April 19, 2022

Re: On-Going Services
Public Improvements Acceptance of Riverwood Ranch Section 2 Subdivision
Angleton, Texas
HDR Job No. 10283980

ENGINEER'S CERTIFICATE OF COMPLETION

RIVERWOOD RANCH SUBDIVISION
SECTION 2
A 78 AC, 109-LOT SUBDIVISION
ANGLETON, TEXAS 77515

PLAN & PROFILE
BENNETT LOOP
STA. 0+00 TO 5+00

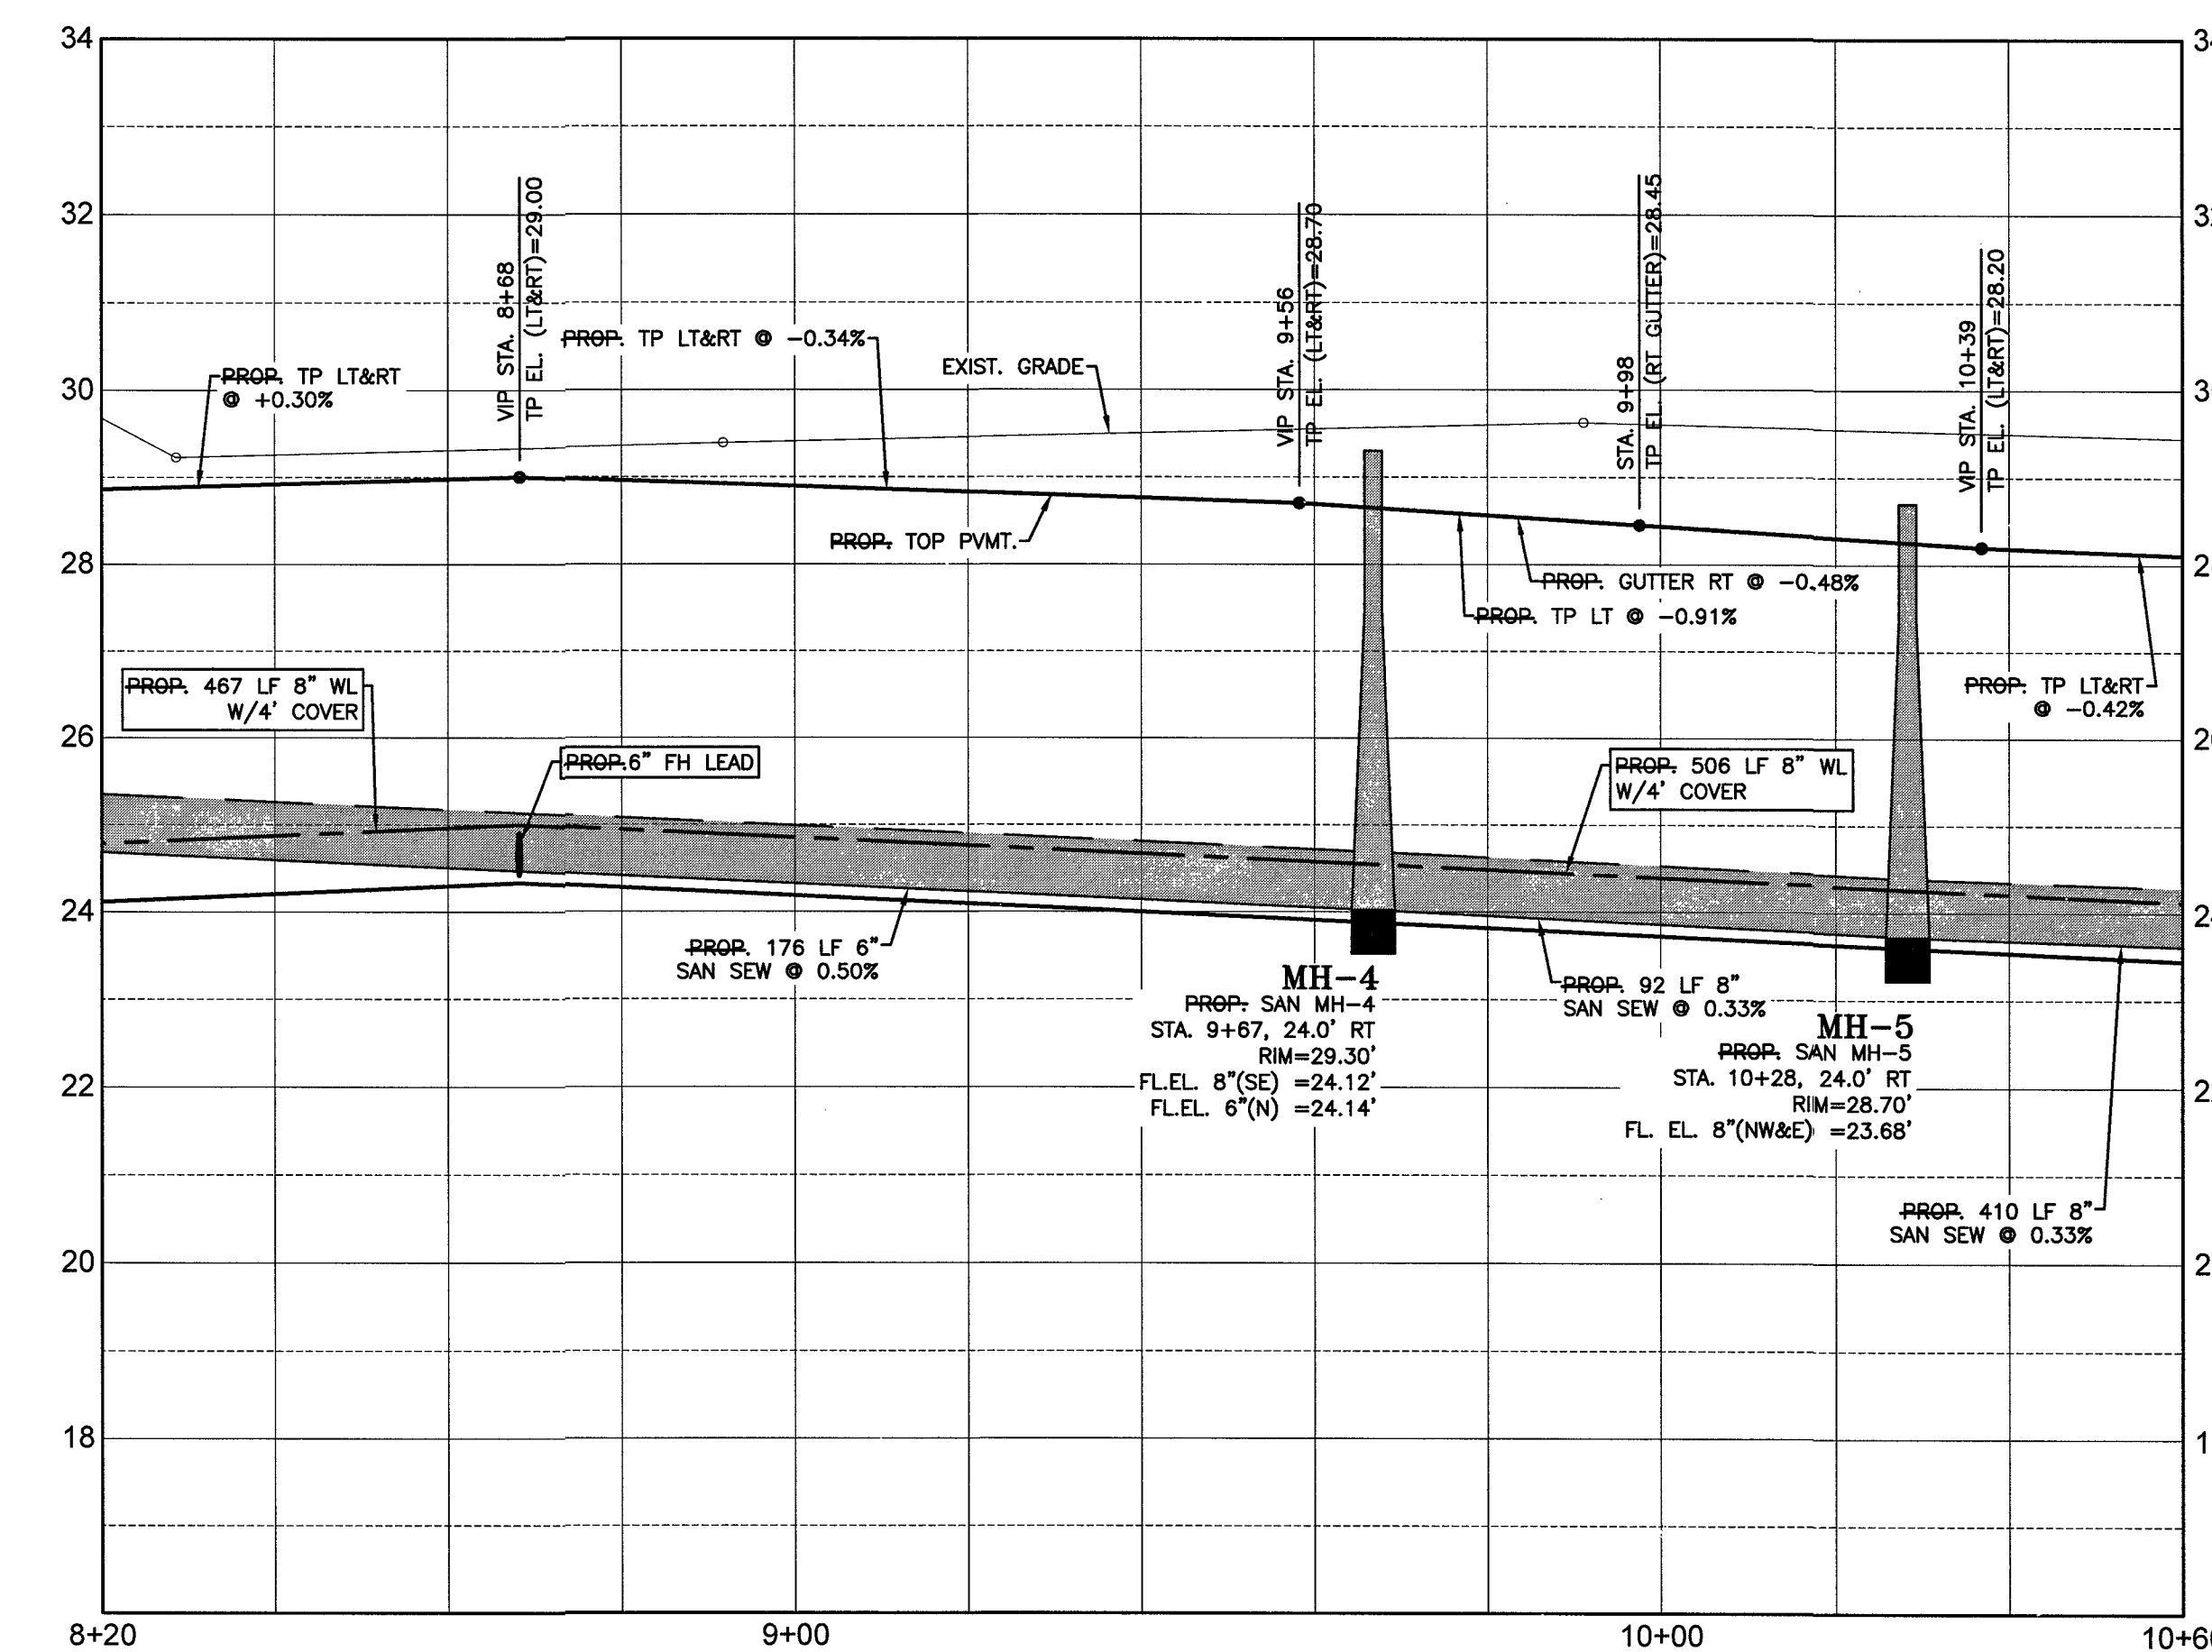
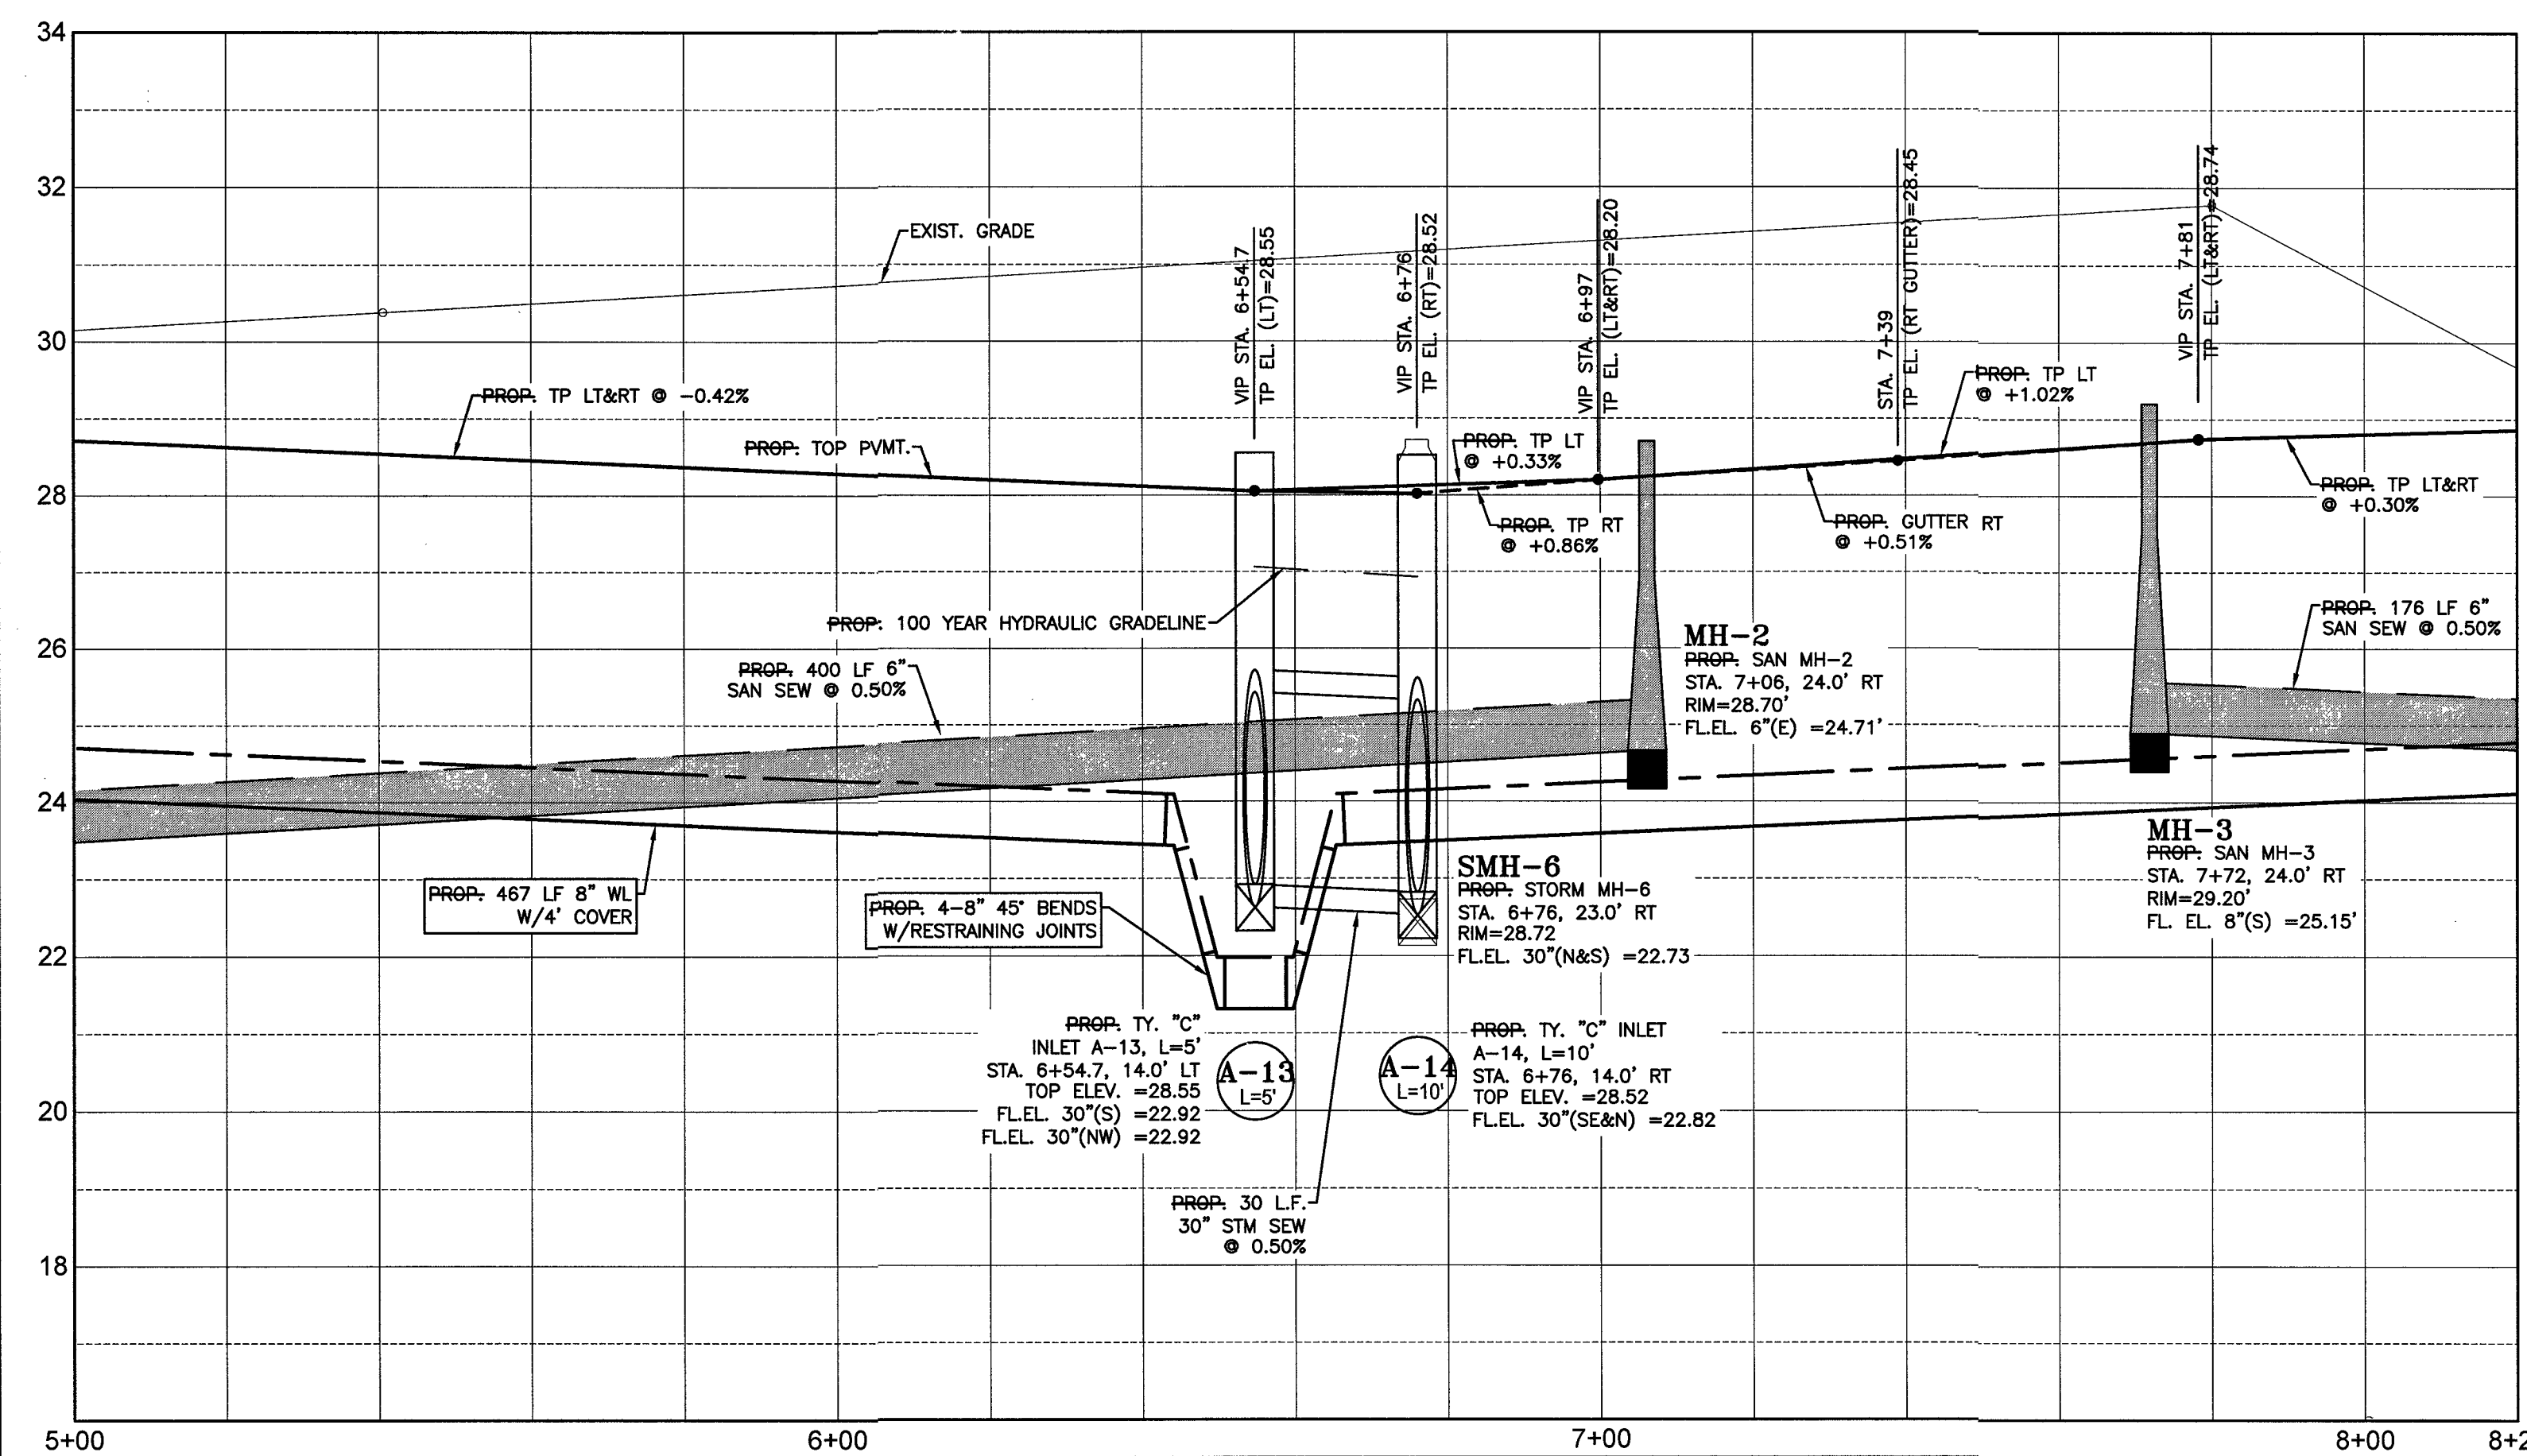
2. During the Final Inspection Walkthrough, a portion of concrete street paving near STA. 4+35 of the left lane on Bennet Loop was noted to have cracking. Public Works has directed the Contractor (Matula & Matula Construction, Inc.) to crack seal this area at this time and that a review of this panel and other street portions shall be provided 1-month prior to the end of maintenance period covered by bonding. Replacement of this concrete panel will be dependent on review of the cracking and if this deficiency has increased over the 1-year period.
